REVISED MAJOR MODIFICATION TO THE OPERABLE UNIT 1 CORRECTIVE ACTION
DECISION/RECORD OF DECISION – JLB-021-00

**Responses to the Environmental Protection Agency Comments on the
Draft Proposed Major Modification to the CAD/ROD for Operable Unit 1**

**Responses to the Colorado Department of Public Health and Environment Comments on the Draft
Proposed Major Modification to the CAD/ROD for Operable Unit 1**

MAJOR MODIFICATION
TO THE
OPERABLE UNIT 1: 881 HILLSIDE AREA
CORRECTIVE ACTION DECISION/RECORD
OF DECISION

OU 1 Collection Well Trichloroethene Concentrations

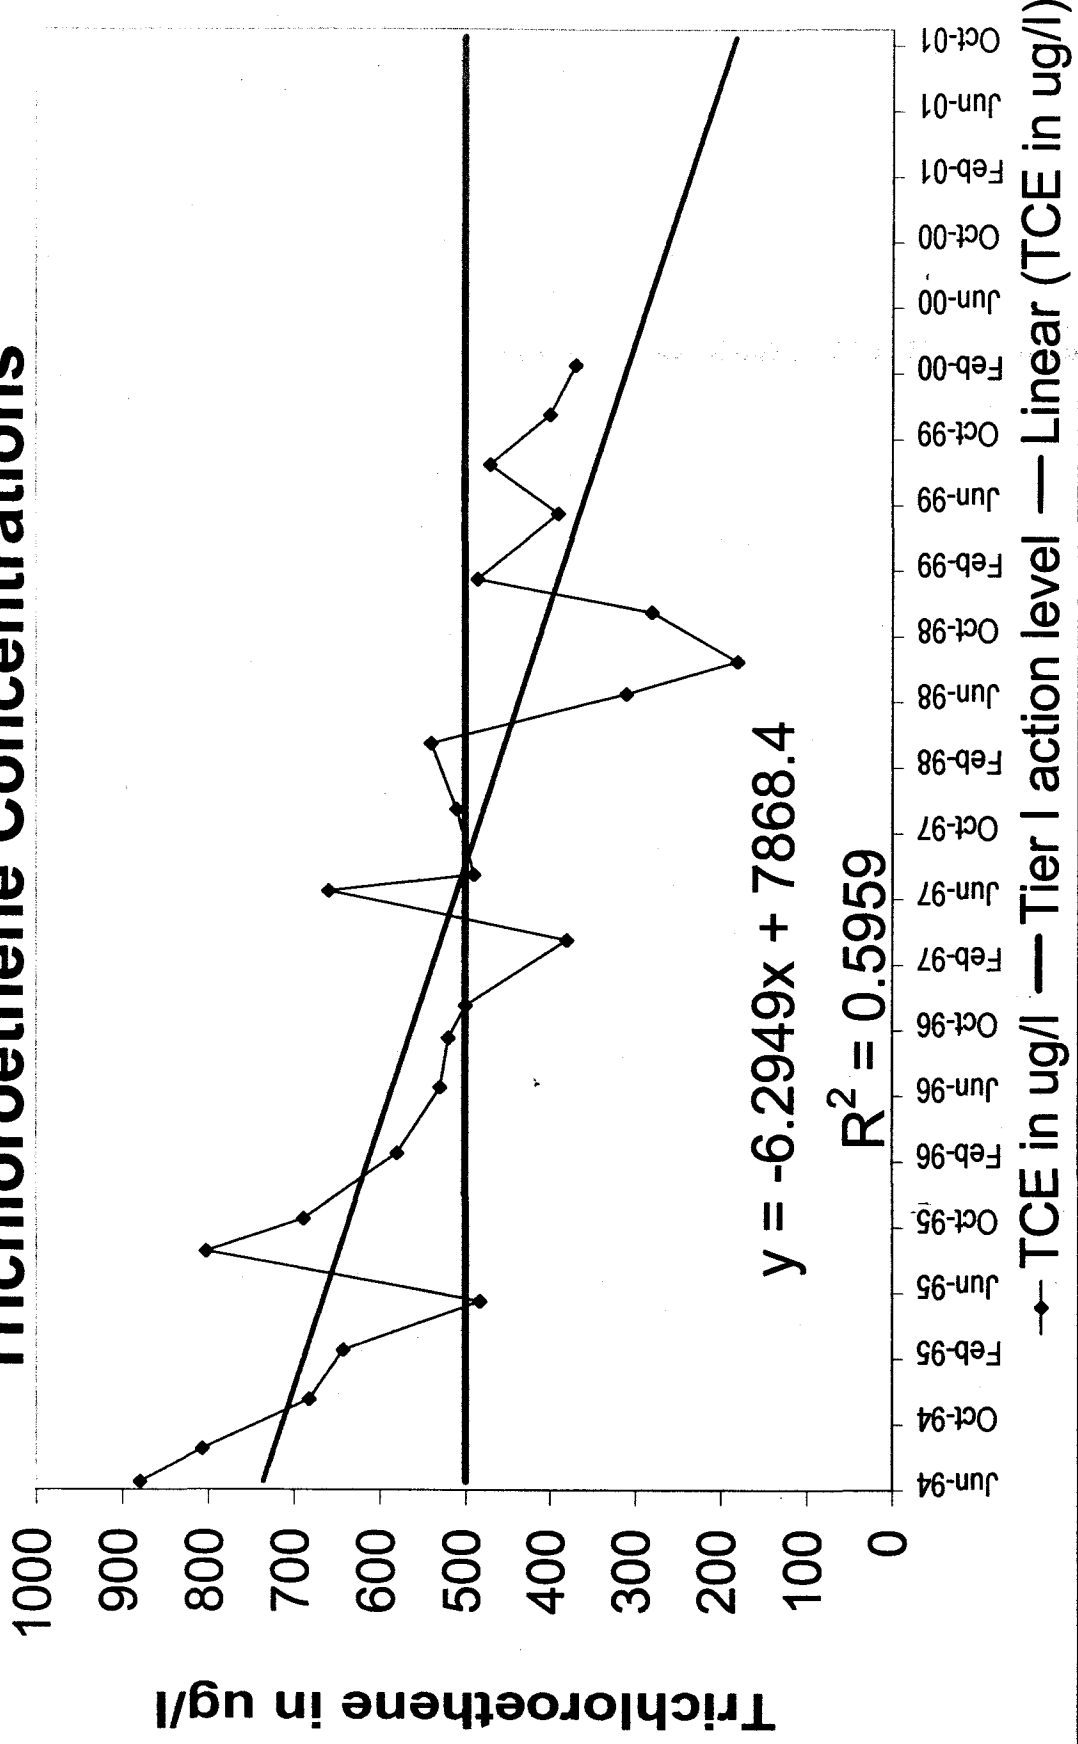
1. **Since a declining trend in concentration, as shown by a linear regression, is the justification for modifying the original remedy, the same justification should be used for discontinuing operation of the Collection Well. Cessation of pumping and treating should occur only if this linear regression of TCE concentrations continues to decline for at least one year following CAD/ROD approval.**

Concentrations of TCE in the Collection Well have remained below the Tier I action level of 500 ug/L since June 1998, and continue to show a declining trend as indicated on the attached concentration plot (also included in the CAD/ROD). Operation of the Collection Well will continue for one year after signing the Major Modification to the OU1 CAD/ROD. After that time, if the declining trend for TCE concentrations in the well continue to be below the Tier I action level (500 ug/L), then pumping and treating of groundwater will be discontinued. The Collection Well will then be designated as a Plume Definition Well and monitored consistent with the RFETS Integrated Monitoring Plan.
